The National Construction Code Volume One

Design Development Report

Child & Adolescent Mental Health Services

Nepean Hospital

Figure No. 27 – Horizontal exit that swings against the direction of egress on Level 02

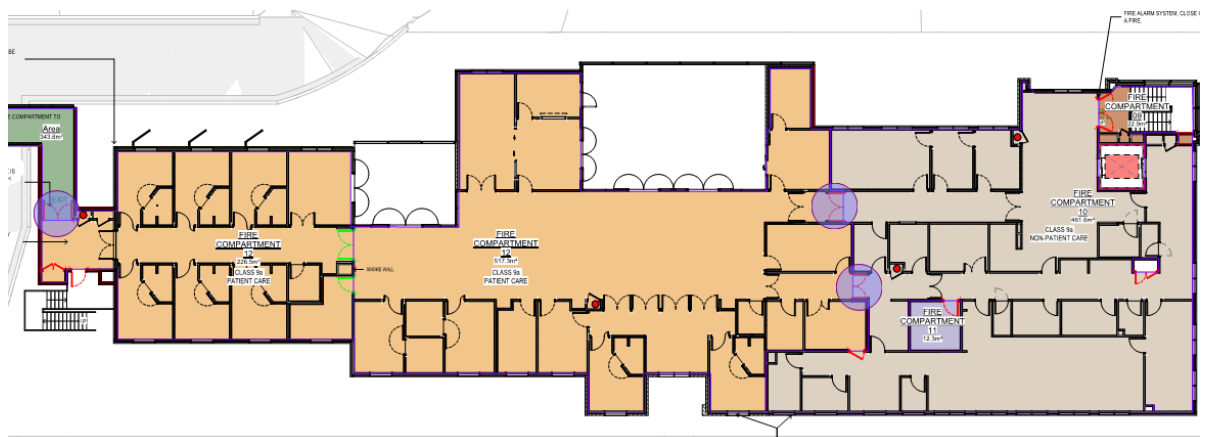
The swing of the horizontal exit doors against the direction of egress is proposed to be assessed as part of the Fire Engineering Assessment to be undertaken by Arup in order to demonstrate compliance with the nominated Performance Requirements of the BCA.

Figure No. 28 – Accessible sole occupancy required to be provided on Level 01

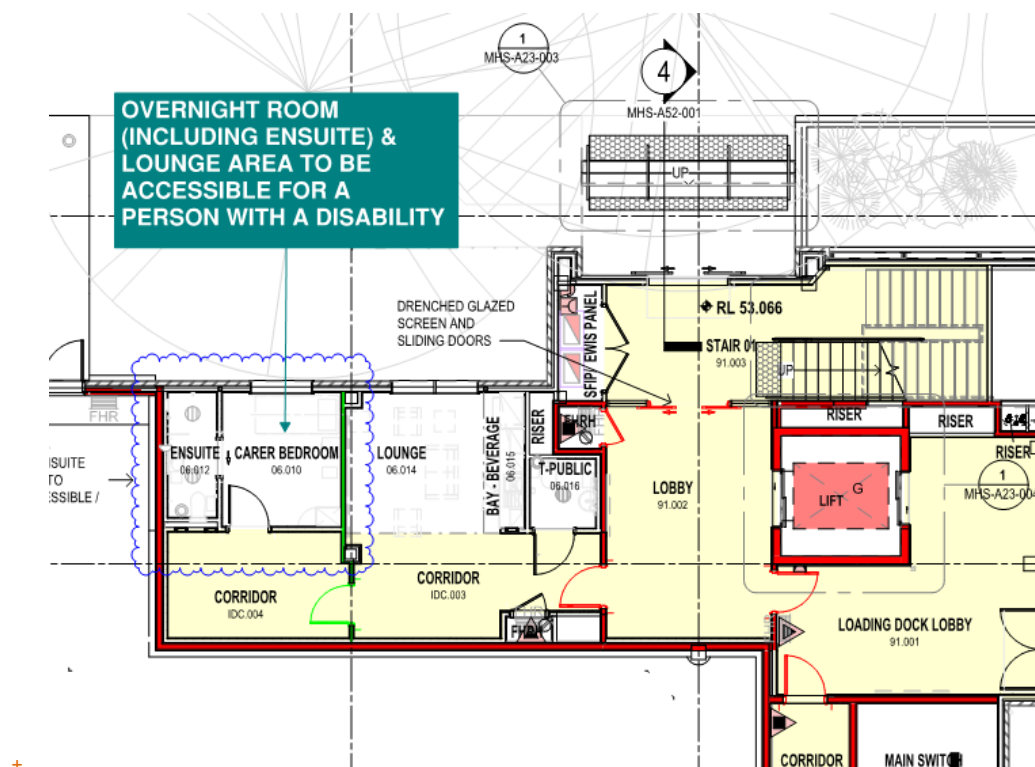
The Class 3 overnight room will be required to be fully accessible for a person with a disability including an accessible sanitary facility (ensuite).

Figure No. 46 – Circulation Space at Swing Doors on Level 01

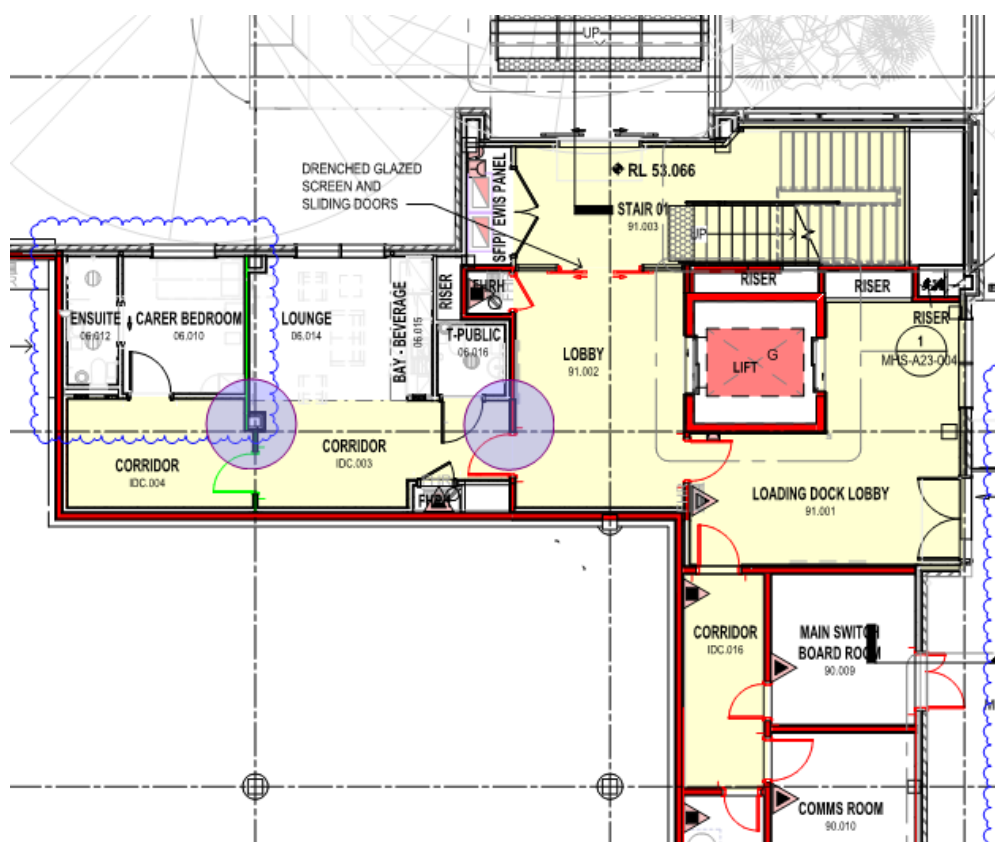
The below figure detail's locations throughout the building where circulation space requires close attention in order to ensure that compliance is achieved with the requirements of AS 1428.1 – 2009 as the design develops.

Figure No. 54 – Rooms on Level 01 that are not required to be accessible for a person with a disability

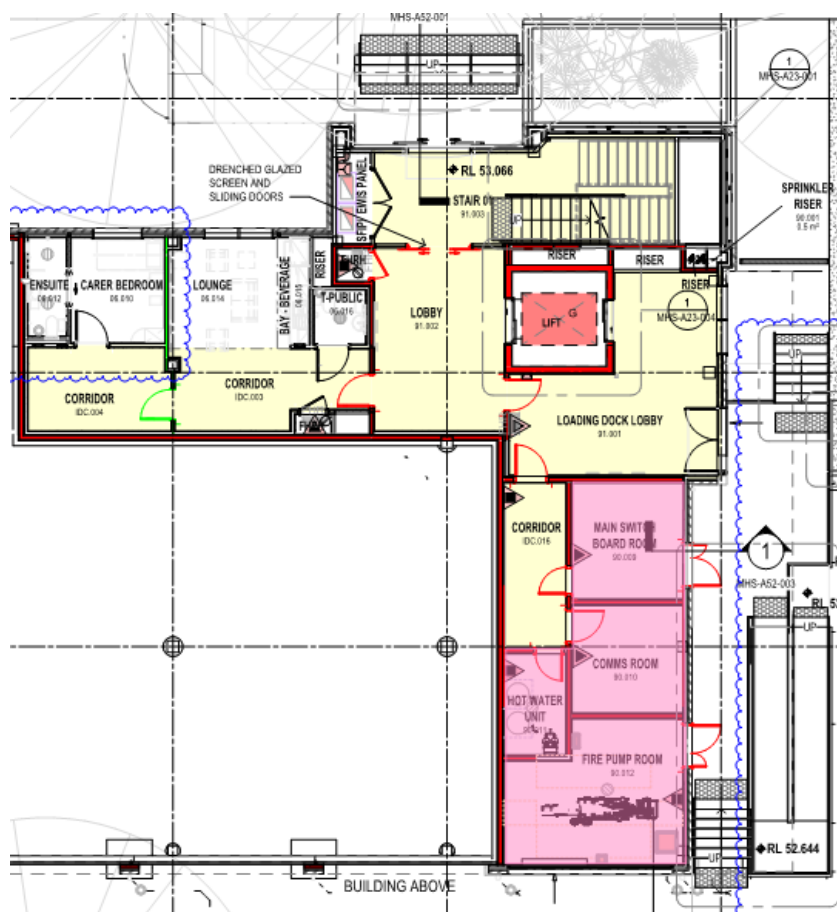
Written verification will be required to be submitted by the Western Sydney Local Health District verifying that a staff member with a disability will not be required to access the above rooms in their role.

Figure No. 57 – Fire hydrant to be located within the fire isolated stairway on Level 01

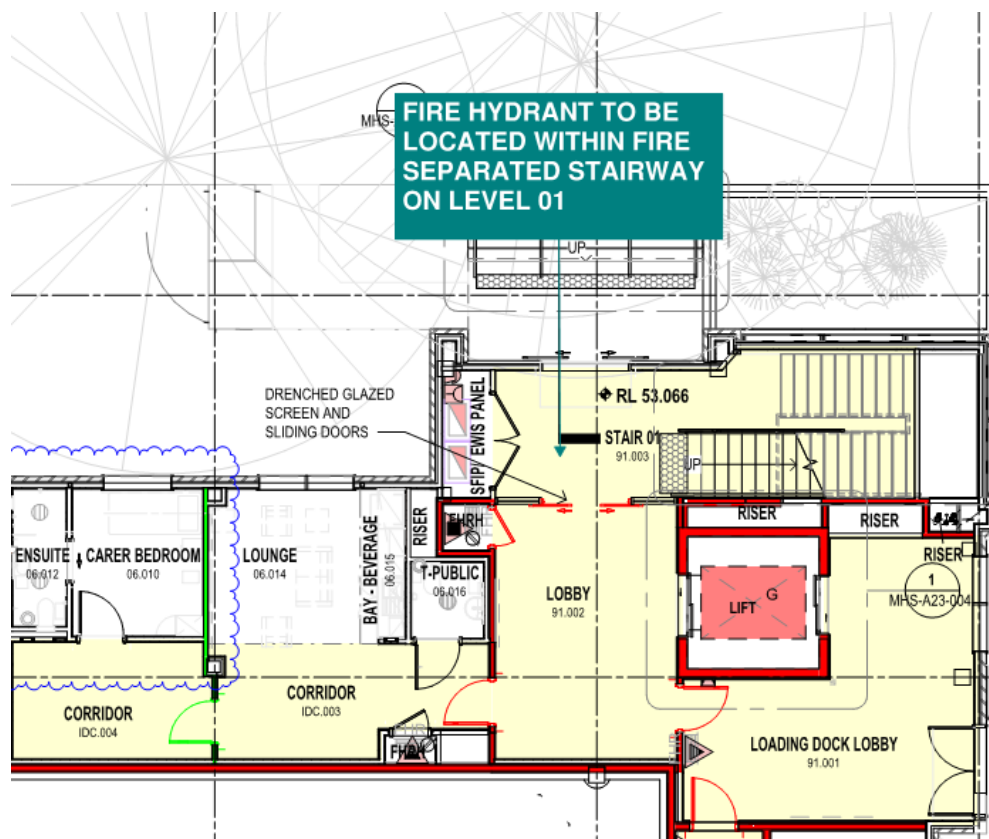
On Level 01, a fire hydrant is required to be located within the fire isolated (separated) stairway as detailed in the figure below.

Figure No. 63 – Separation of sprinkler v non-sprinkler protected parts of the building

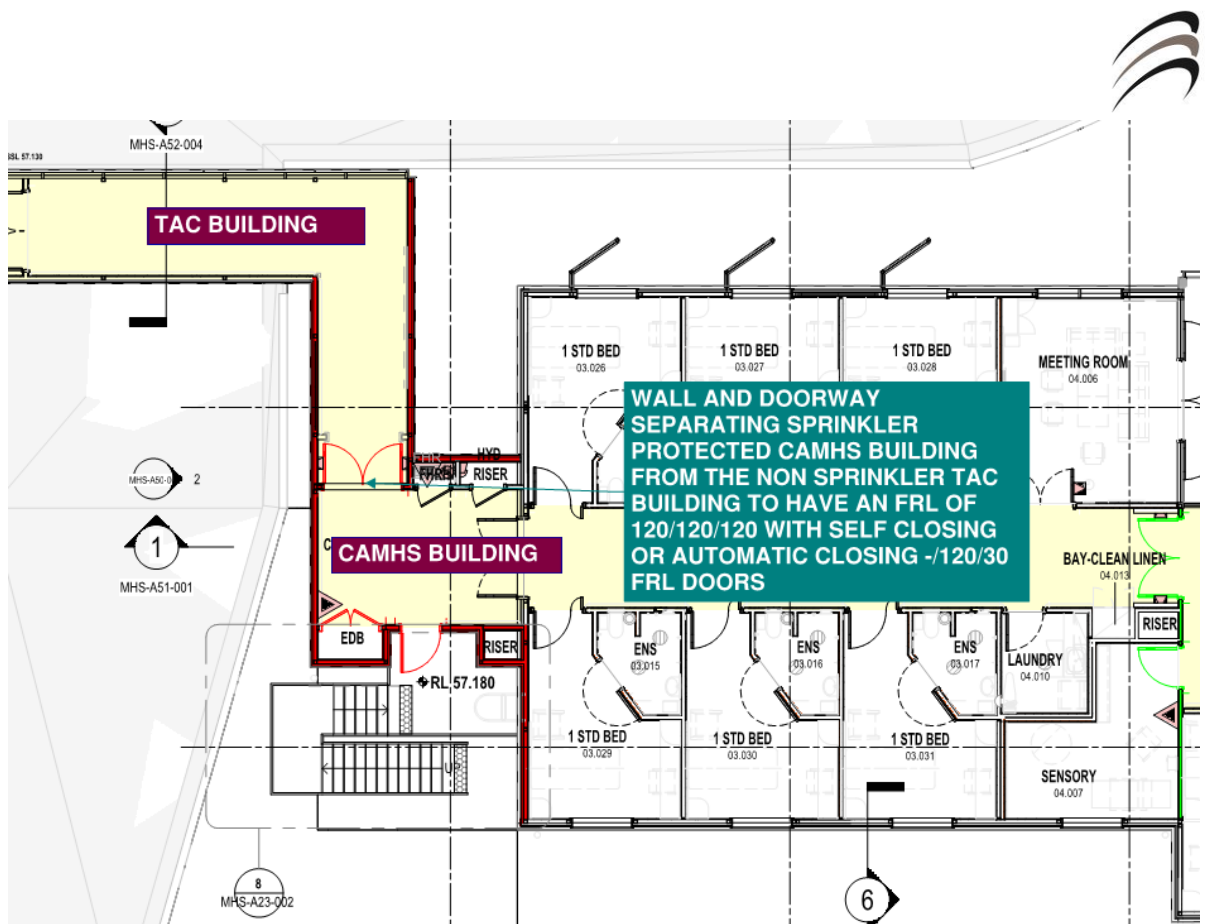
The wall separating sprinkler protected and non-sprinkler protected areas will be required to have a minimum FRL of 120 mins as detailed in figure below.
